[Docket No. FAA-2013-0486; Directorate Identifier 2010-SW-031-AD]

#### Airworthiness Directives; MD Helicopters, Inc. (MDHI), Helicopters

**ACTION:** Notice of proposed rulemaking (NPRM).

Figure 1 to paragraph (e) of this AD

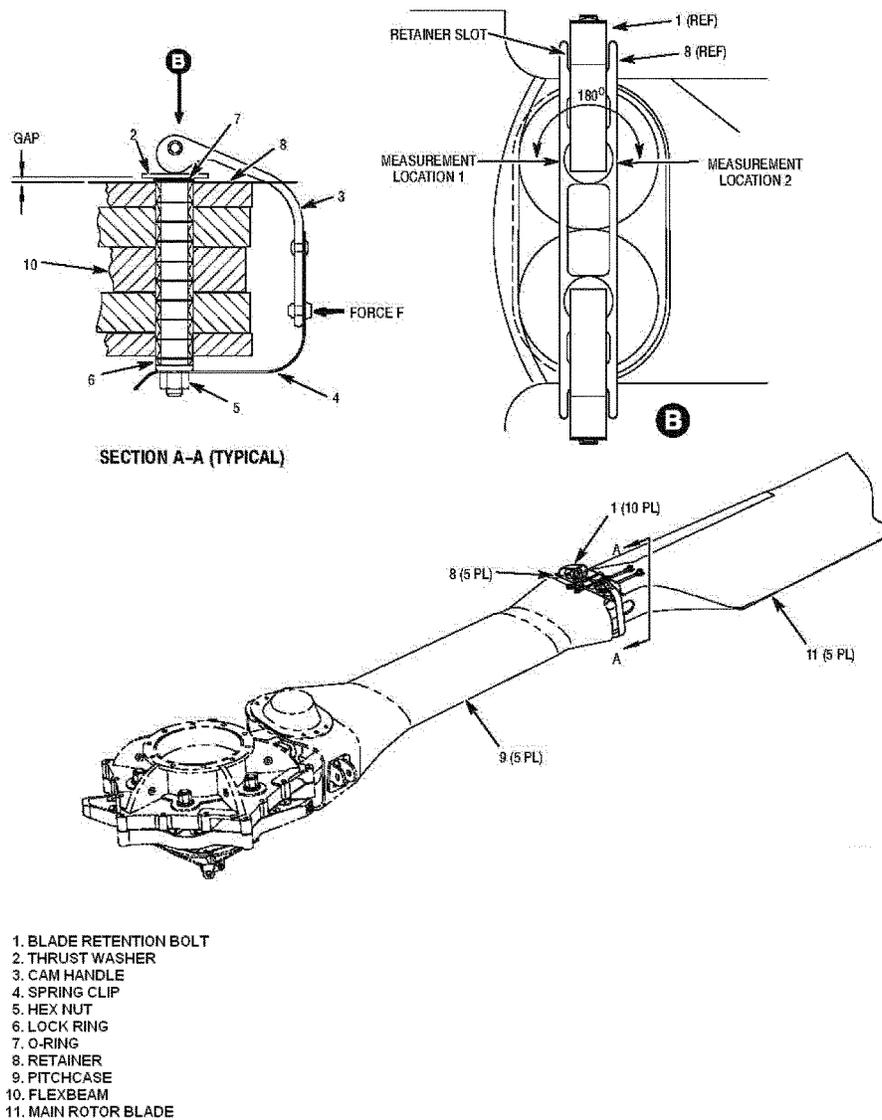
- (1) Before the first flight of each day:
  - (i) Visually check each bolt for failure. Failure of a bolt may be indicated by movement of the bolt out of the bolt hole or by inconsistent extension of the bolt above or below the other bolts being inspected (a failed bolt migrates out of the bolt hole).
  - (ii) Visually check for a gap between the thrust washer and the retainer, P/N 900R2100009–101 or –103. The thrust washer is depicted as item 2 and the retainer is depicted as item 8 in Figure 1 to paragraph (e) of this AD.

(iv) If there is any indication of bolt failure or if there is no gap between the thrust washer and retainer, before further flight, remove and inspect the bolt for a crack.

(iii) If there is a gap between the thrust washer and retainer, measure the gap in two locations, 180 degrees apart, with a feeler gage. If the gap is more than 0.100 inch (2.54 mm) at either location, before further flight, remove and inspect the bolt for a crack. Replace any cracked bolt with an airworthy bolt.
